RE: SES Solar One Project
Applicant's Responses to the CEC Memo Regarding Transmission Line Upgrades

SES Solar One
Response to CEC Memorandum
Docketed 12/8/2009
08-AFC-13

TECHNICAL AREA: TRANSMISSION LINE UPGRADES

Path: G:\projects\157727658100\pdx\T-Line\Time_sols_map_22\34.mxd, 01/06/10, comille_jill

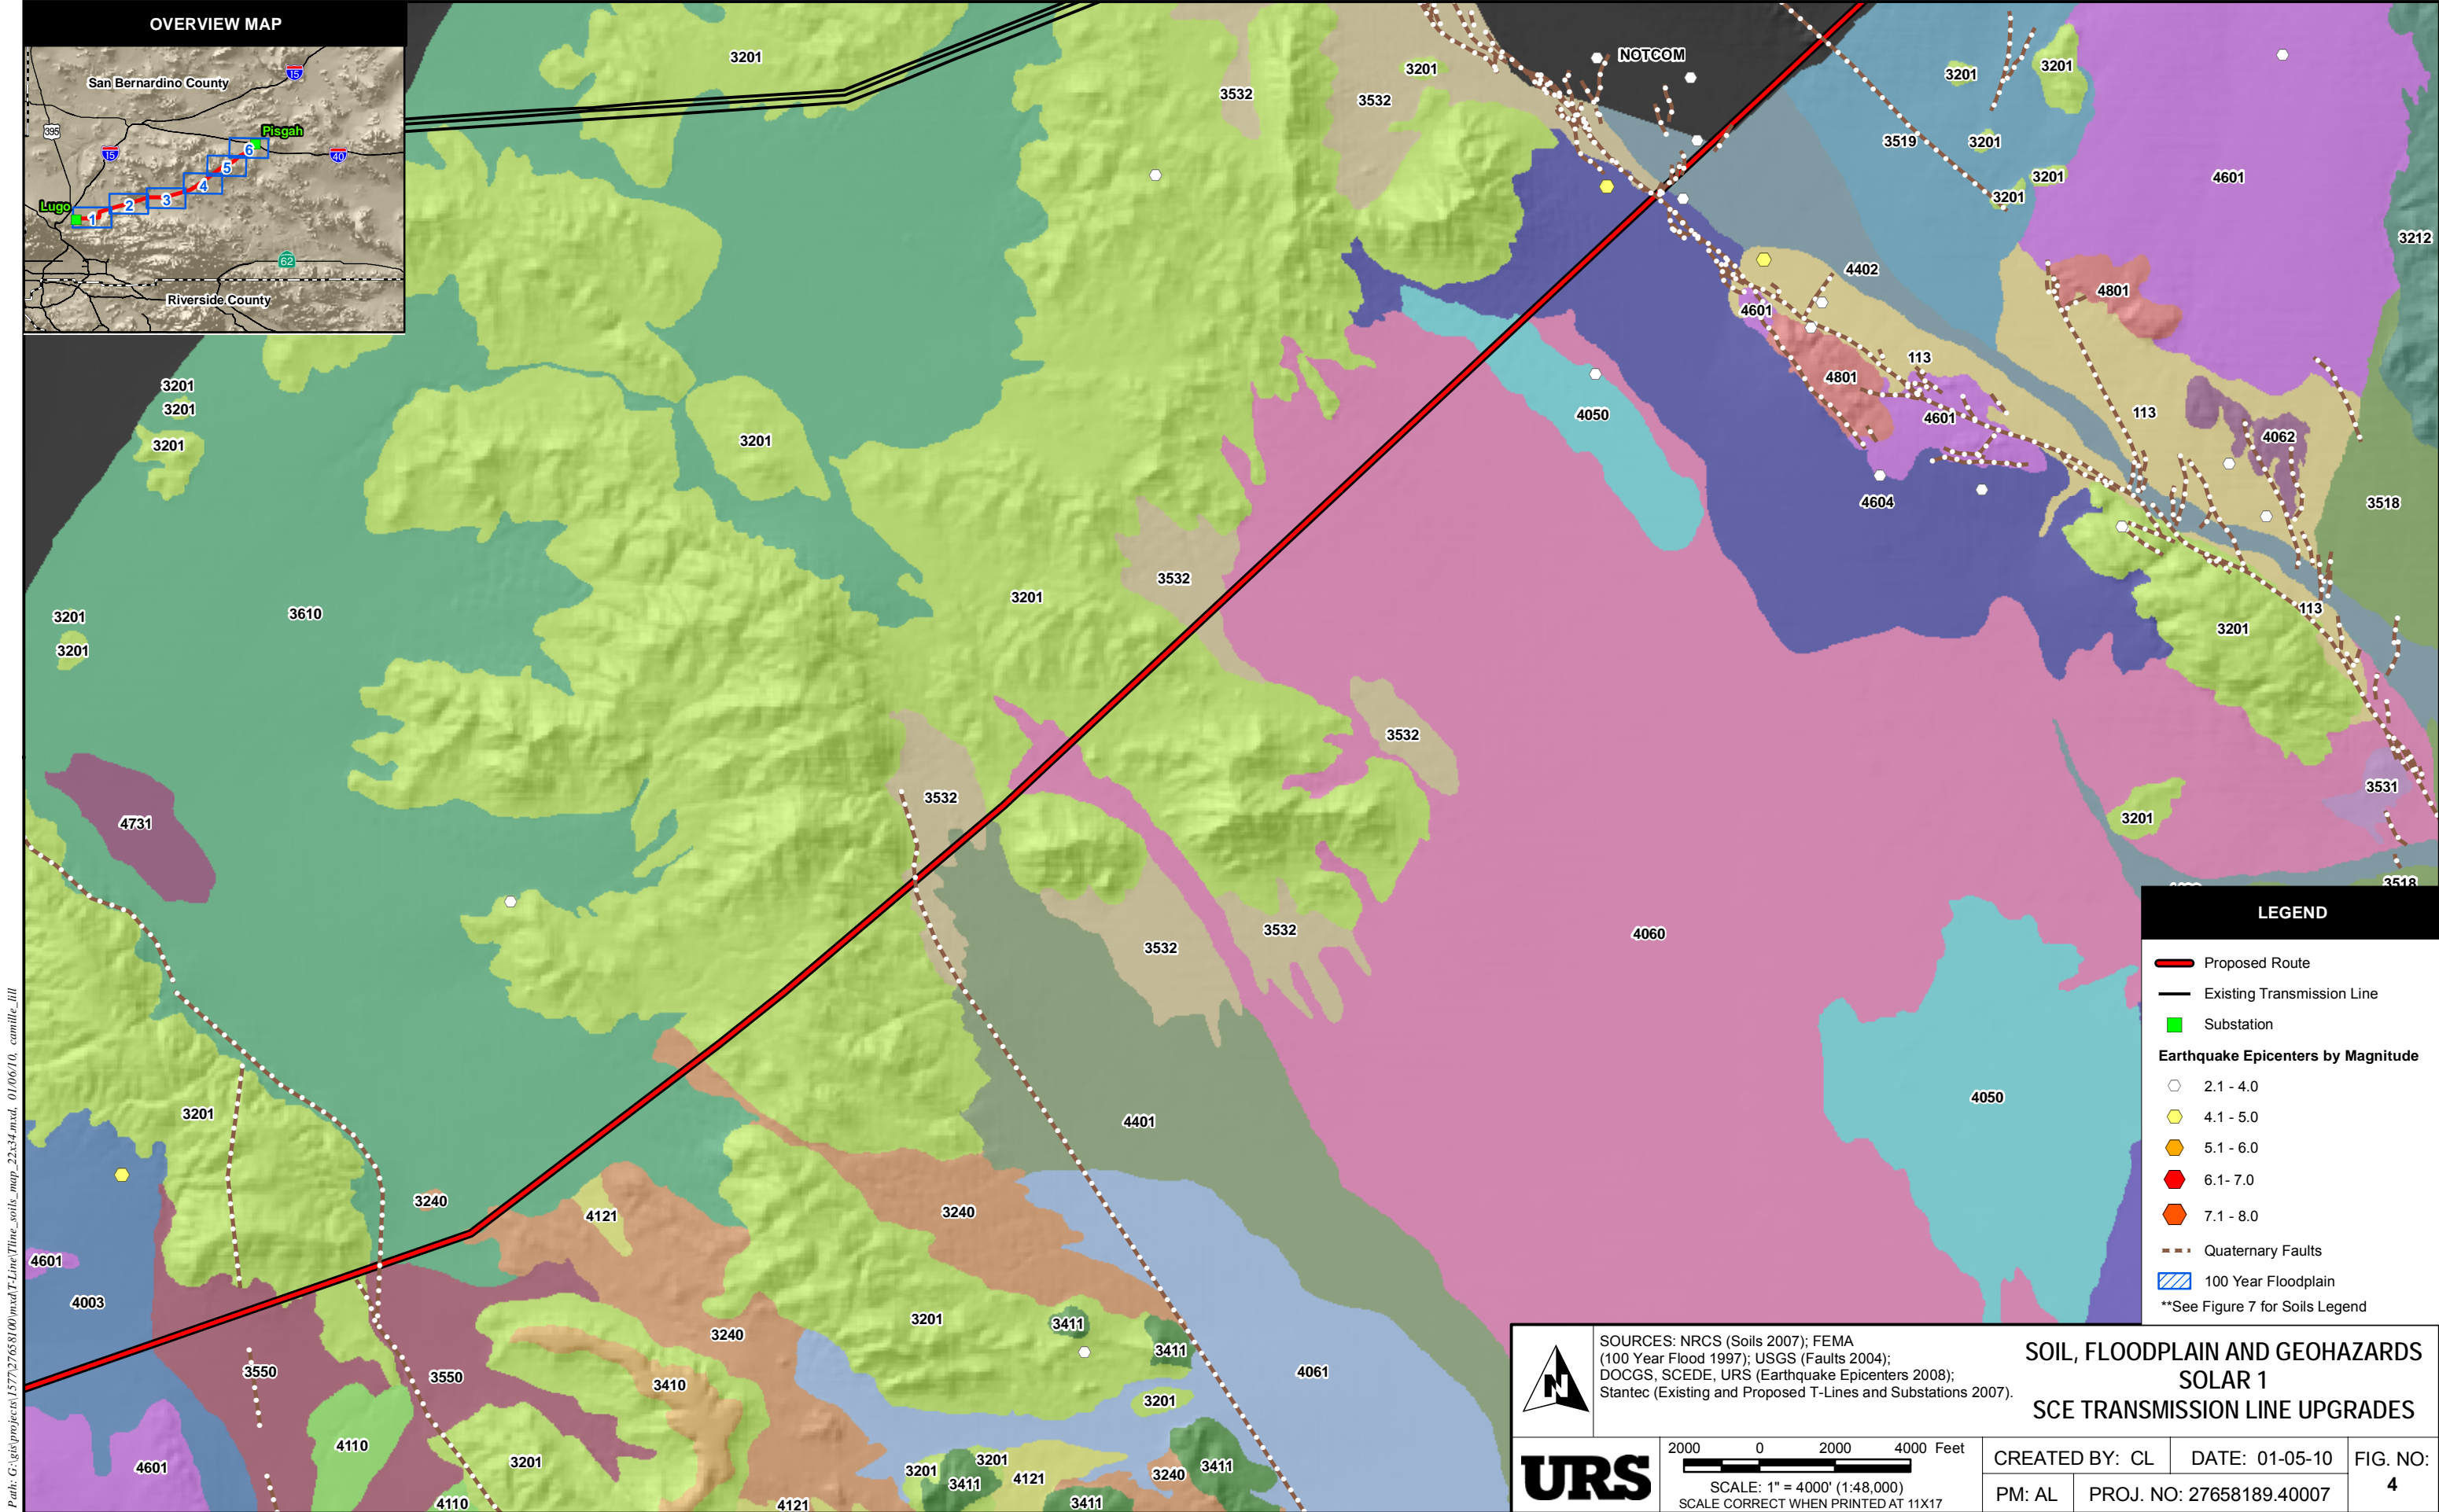
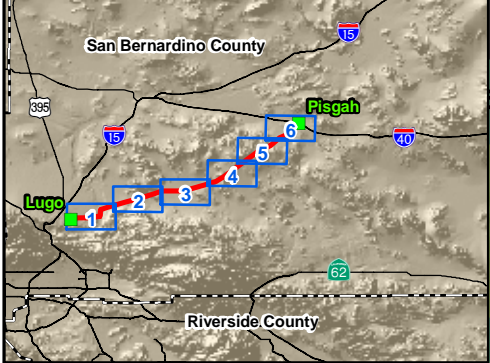
Item 8: Identify locations where the alignment of transmission line upgrades cross 100-year flood zones.

Response: The location of the transmission line alignment in relation to FEMA's Flood Insurance Rate Map Zones, including Zone A (the 100-year flood zone), is provided in attachment TRANS-4, located behind this response.
